ADDENDUM NO. 2

**Federal Aid Project No. HIP(NGB)-003S(963)X
Bridge Replacement, H-18-004, Salisbury Street over G&W Railroad**

QUESTIONS AND RESPONSES

MDC WATER DIVISION EASEMENTS

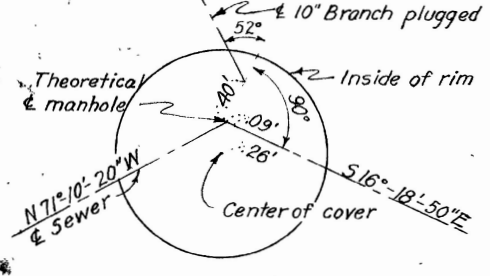
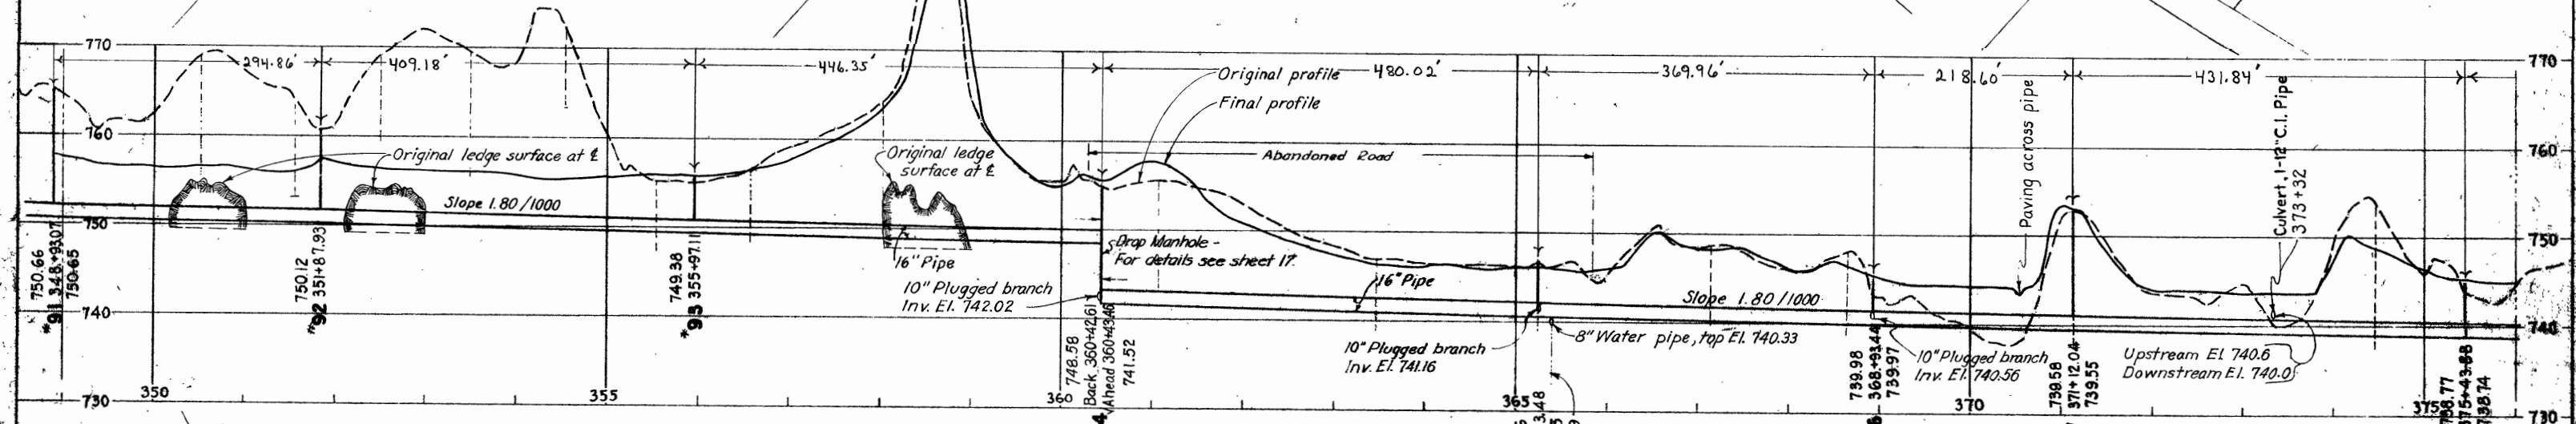
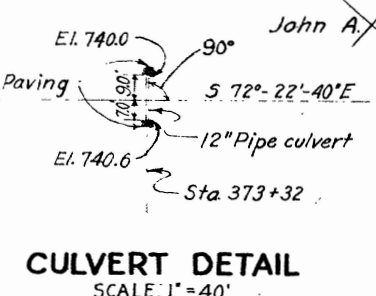
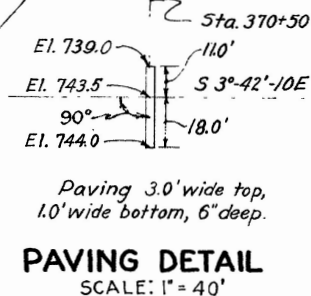
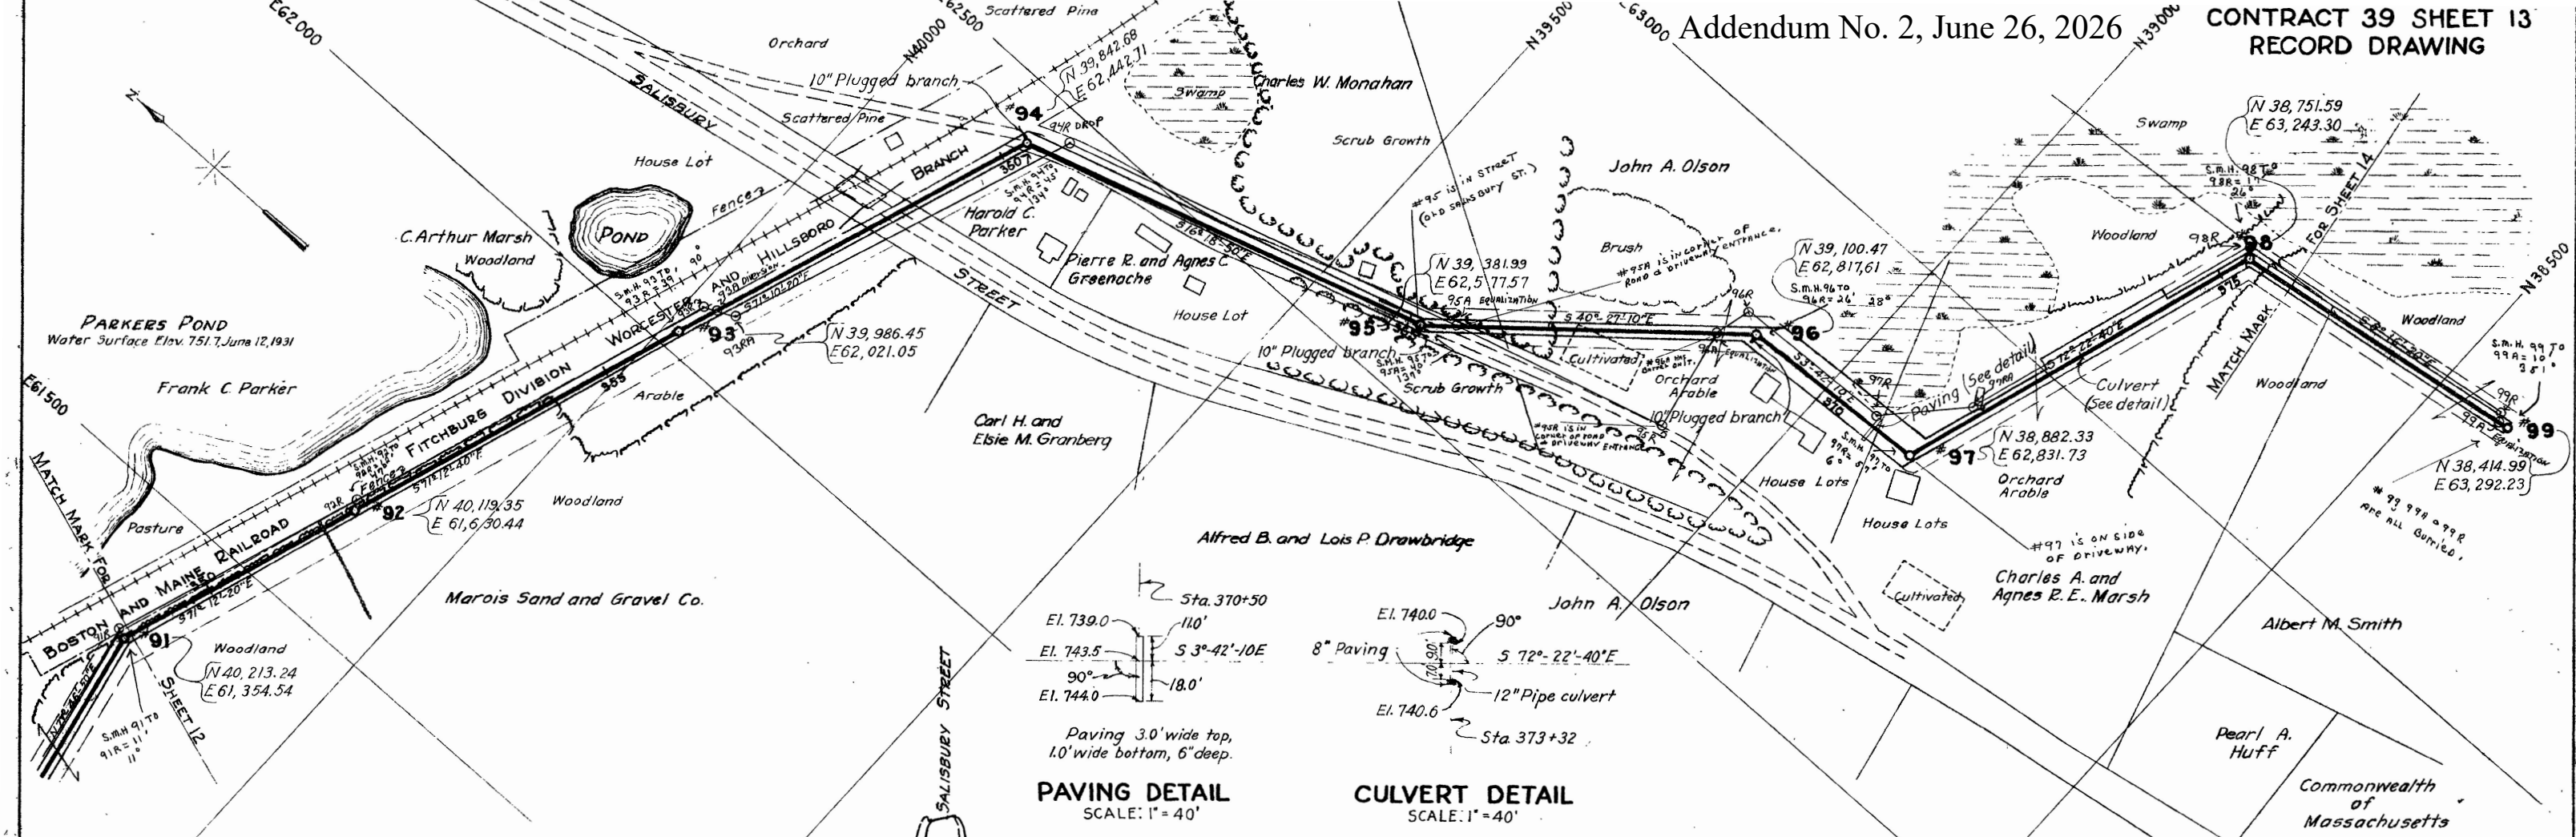
Question #3: Contract Drawing Sheet 25 of 81, Utility Plans, shows the M.D.C. Water Division Sewer easements. Please provide the elevations of the M.D.C. 16" and 24" sewer pipes within the proposed contract layout area.

Response #3: See the new Document A00804 in this addendum, which are the existing drawings depicting plan and profile views of the 16" and 24" sewer pipes in the easement crossing Salisbury Street.
